NARWEE PARKLANDS CARE COMMUNITY

SSDA SUMMARY OF DESIGN CHANGES FOR DPE

Response to Submission Design Report for the Narwee Parklands Care Community

State Significant Development Application (SSD-45024776)

21st of March - Proposed Design

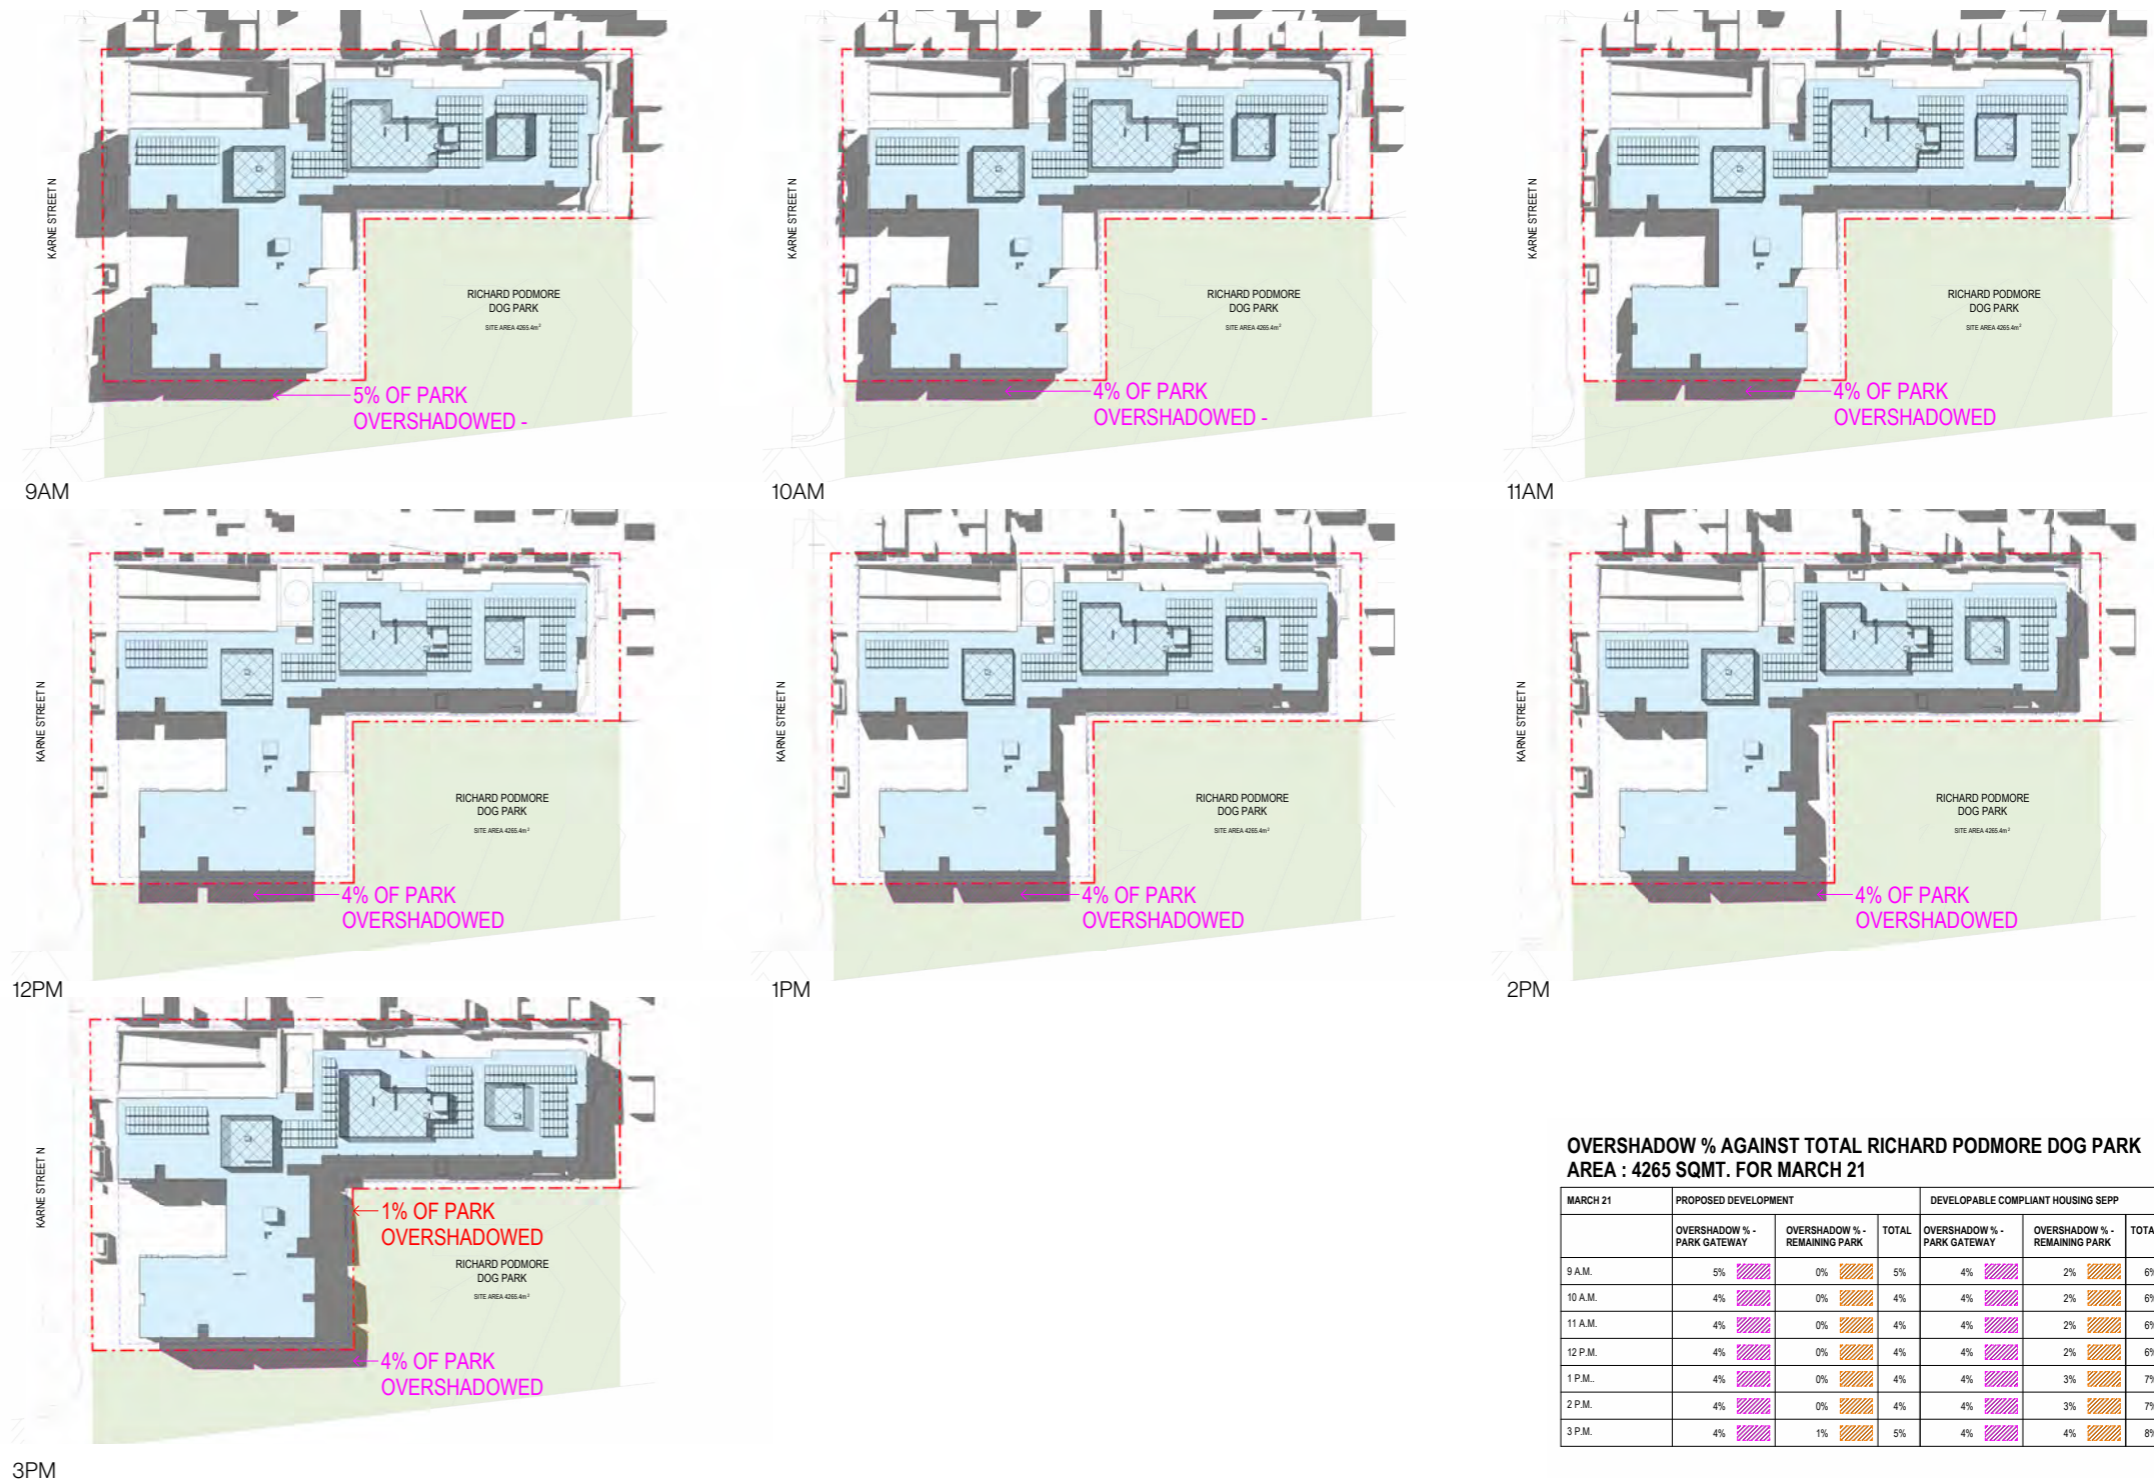
(d) Amended shadow diagrams are to be submitted that remove reference to the previous development on the site. The shadow diagrams must compare the impacts of the proposal against a complying built form.

The adjacent diagrams demonstrate shadows during March equinox. The proposed development - overshadowing to the Richard Podmore Reserve has a positive impact in comparison to the complying built form.

21st of March - Developable Compliant Housing SEPP

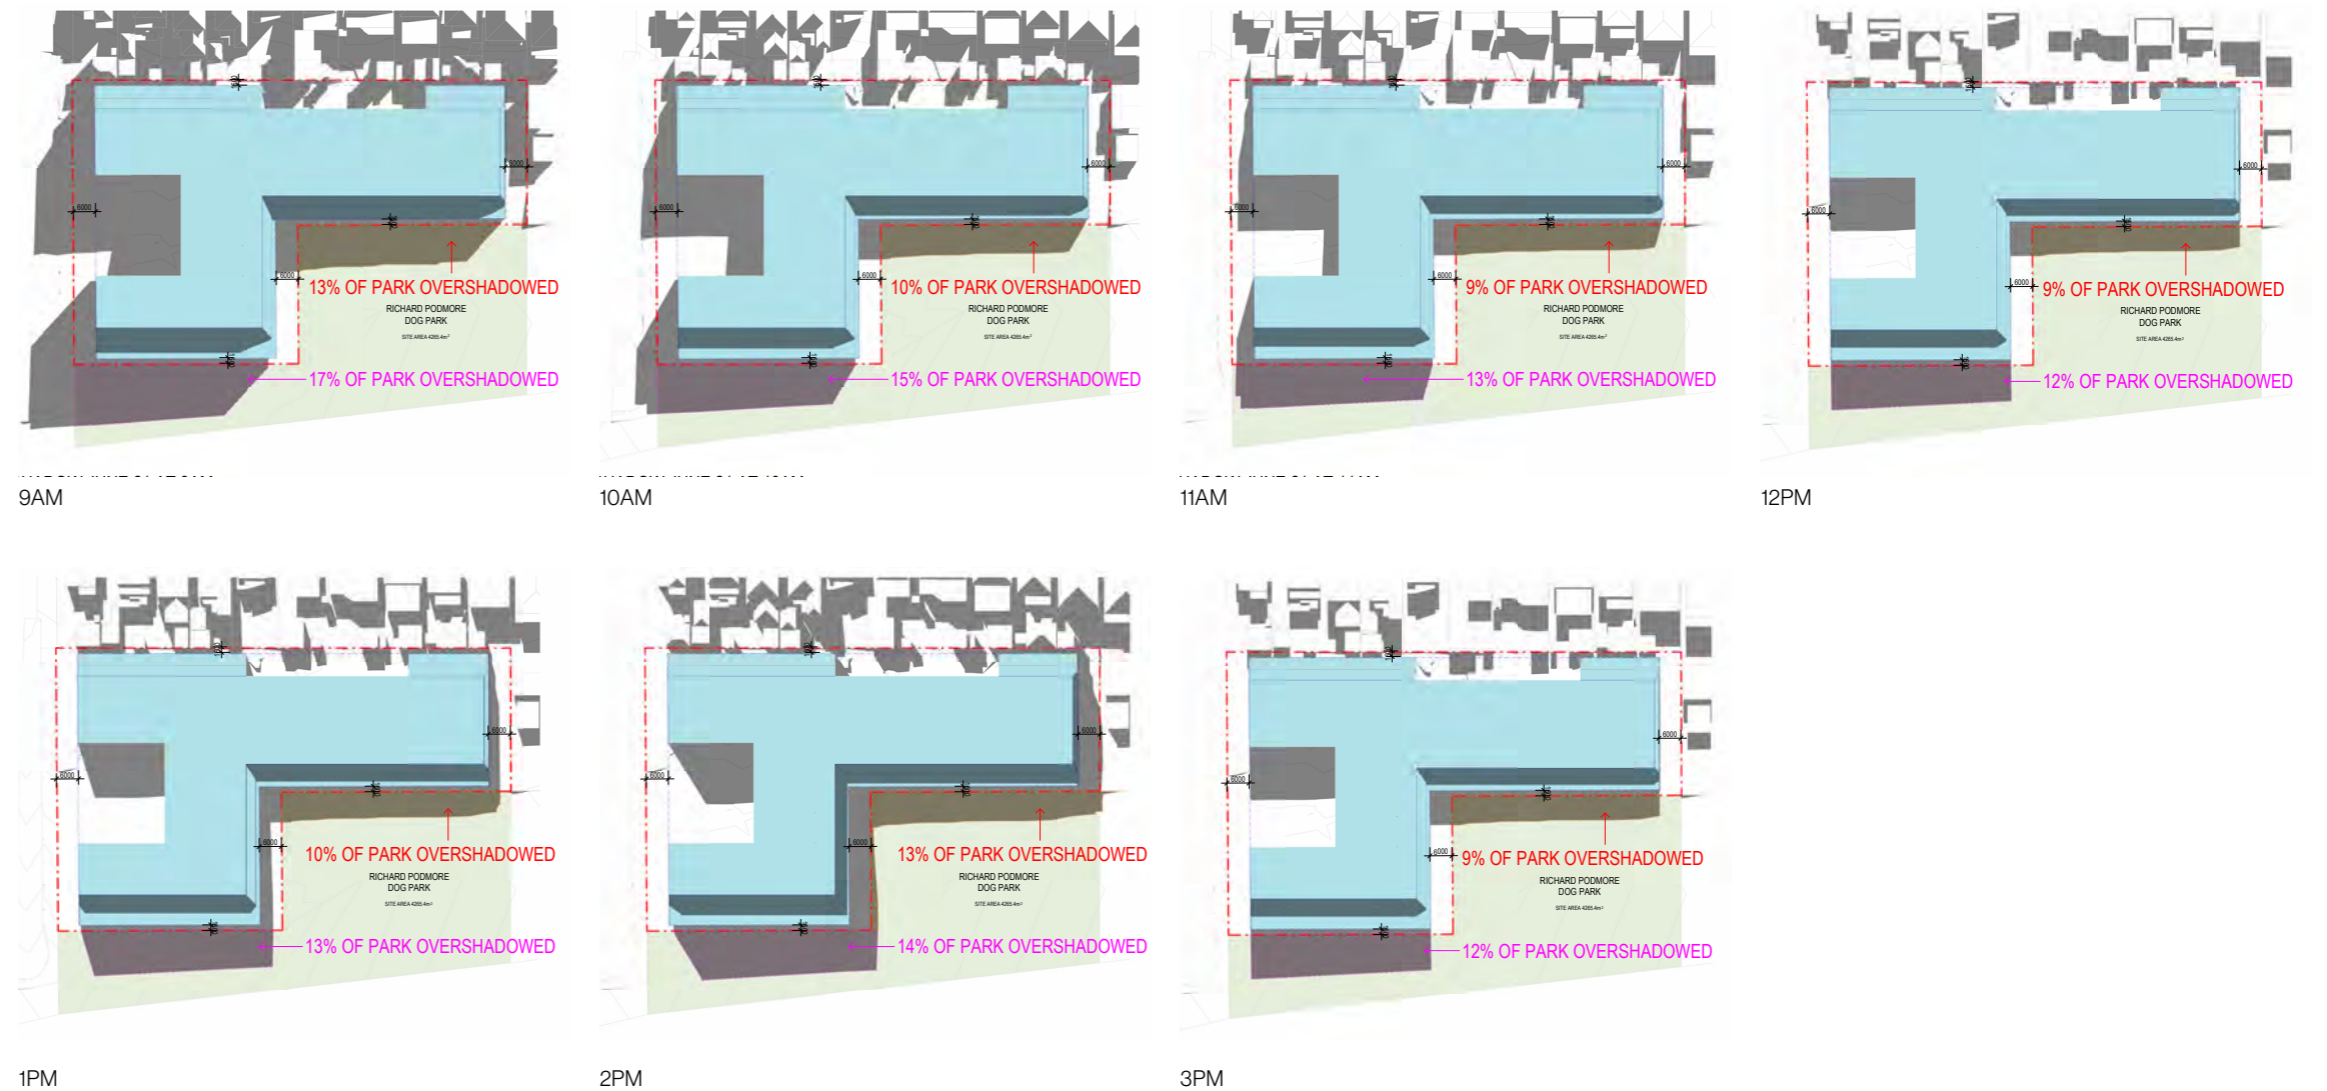
(d) Amended shadow diagrams are to be submitted that remove reference to the previous development on the site. The shadow diagrams must compare the impacts of the proposal against a complying built form.

The March Solstice Diagrams demonstrate the Developable Compliant Housing SEPP overshadowing for comparison.

23rd of September - Proposed Design

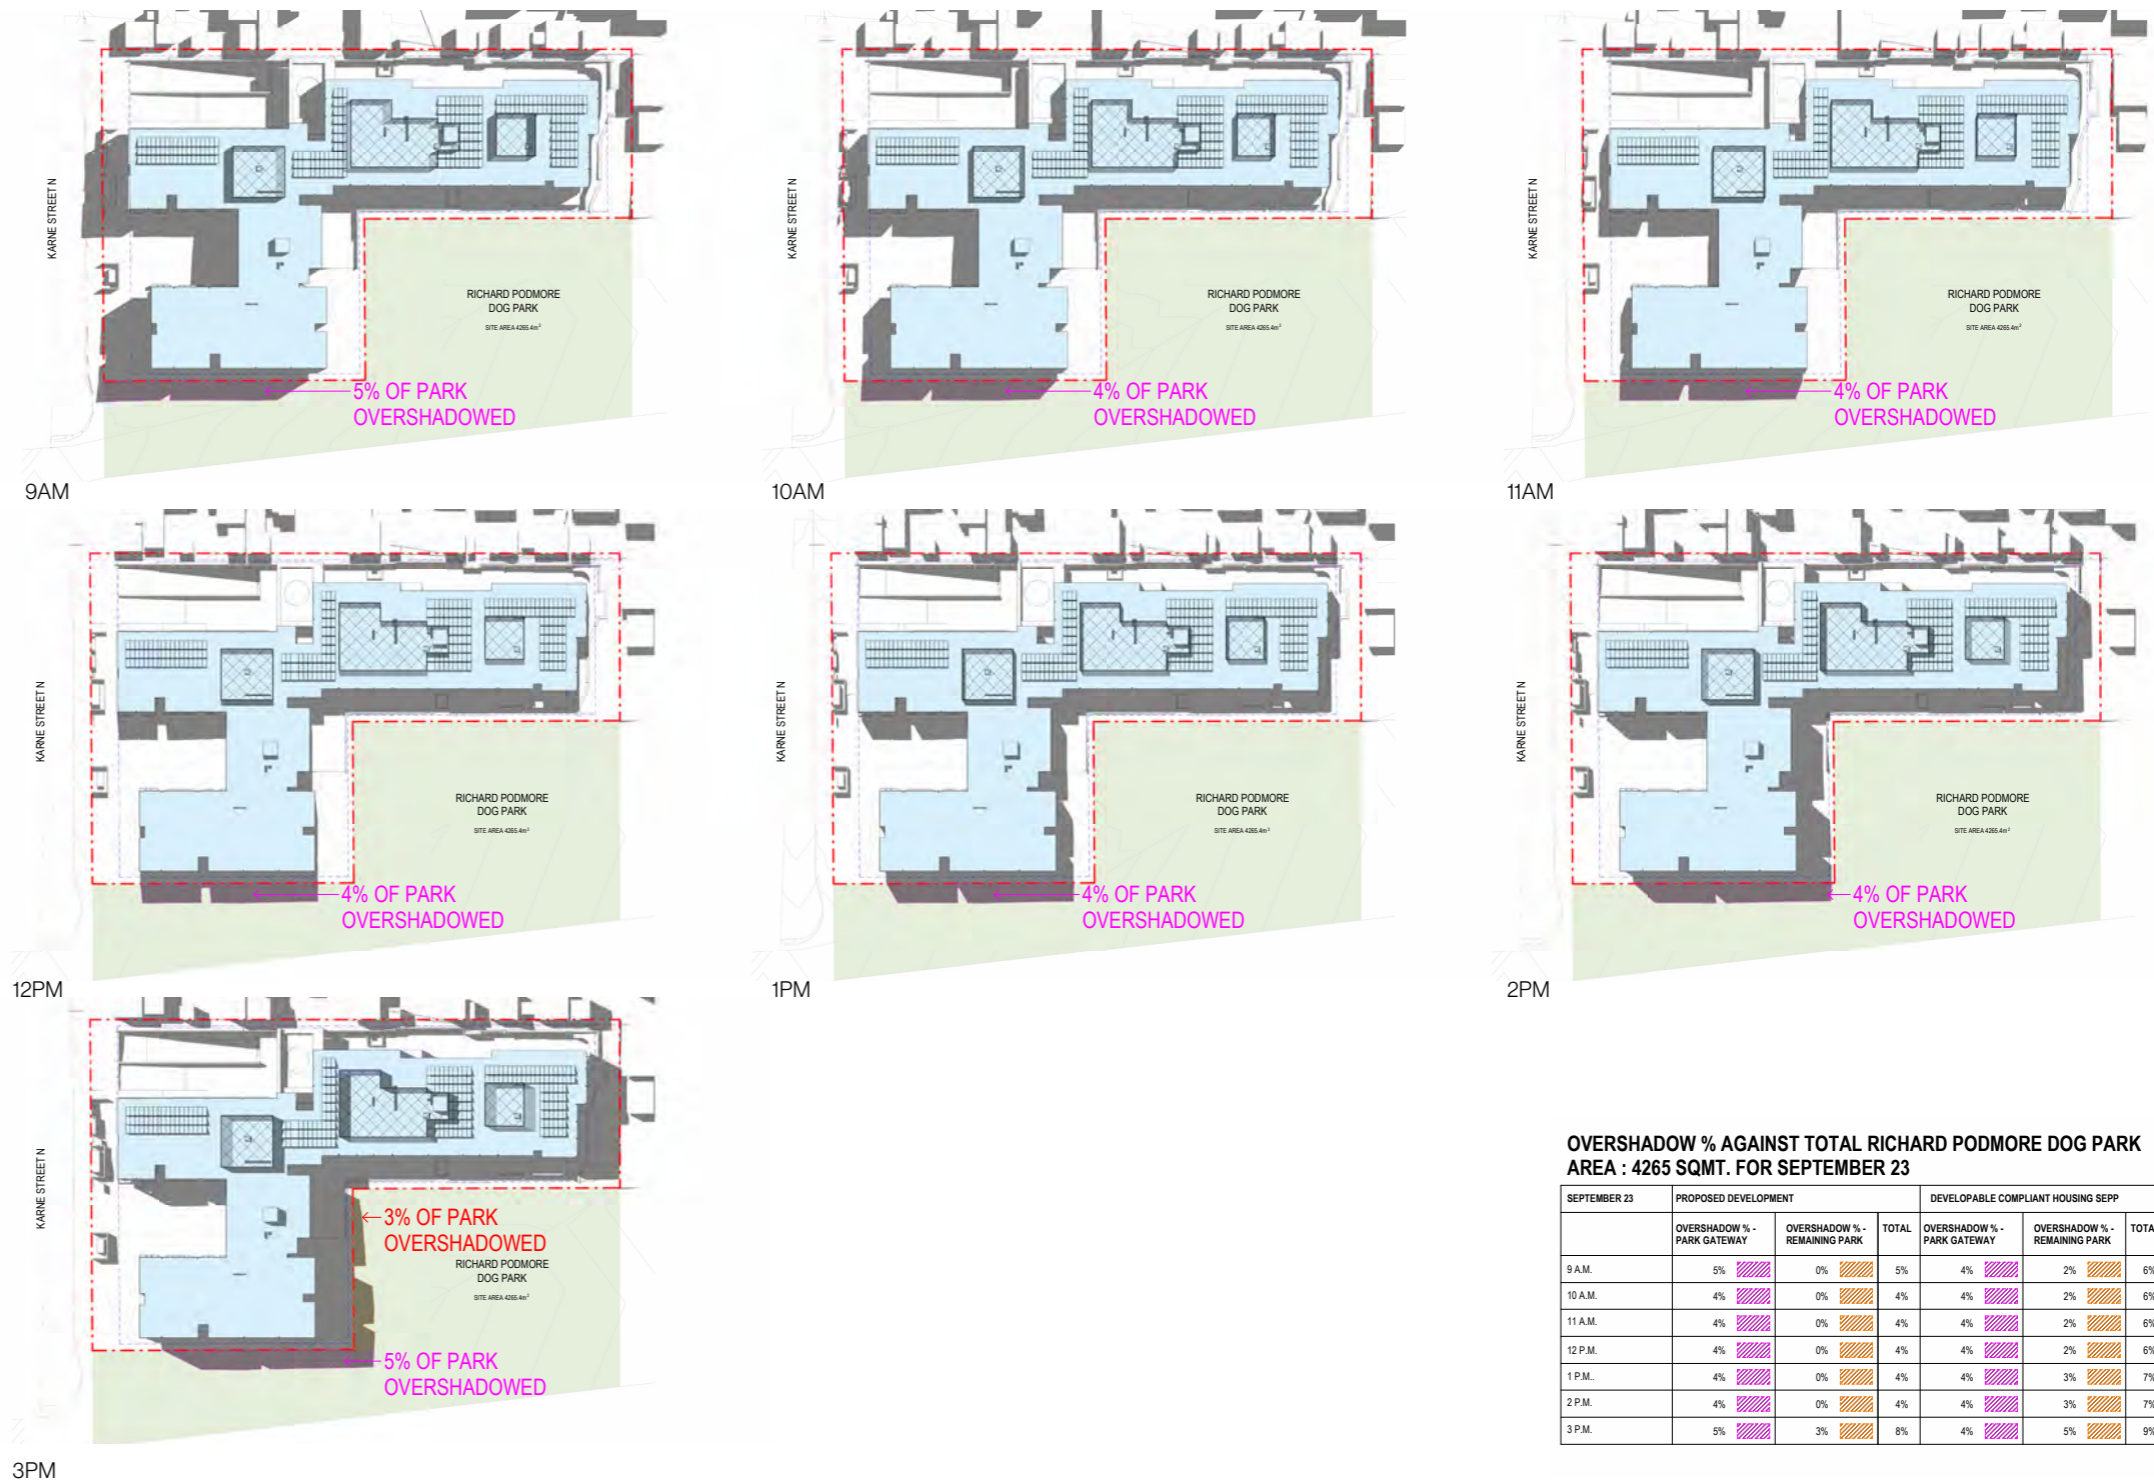
(d) Amended shadow diagrams are to be submitted that remove reference to the previous development on the site. The shadow diagrams must compare the impacts of the proposal against a complying built form.

The adjacent diagrams demonstrate shadows during September equinox. The proposed development - overshadowing to the Richard Podmore Reserve has a positive impact in comparison to the complying built form.
